**Engine Control Module: All Technical Service Bulletins****Recall - Corrosion/Moisture Entering the PCM**

Product Emission 99090 - PCM Corrosion/Moisture Intrusion #99090

99090--PCM Corrosion/Moisture Intrusion (Install Protective PCM Shield/Cover Assembly)

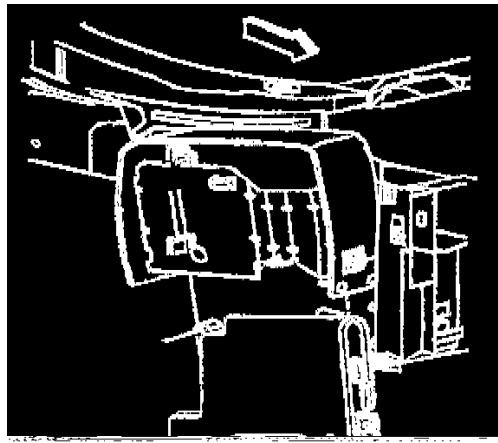
1. Disconnect the negative battery cable.
2. Remove the right-hand engine splash shield (in front of the right front tire assembly)
3. Remove the horn attachment bolt. Disconnect the wire and remove the horn.

4. Remove the PCM retainer attachment bolts (2). Slide the PCM and the retainer from the PCM and the retainer from the PCM bracket.
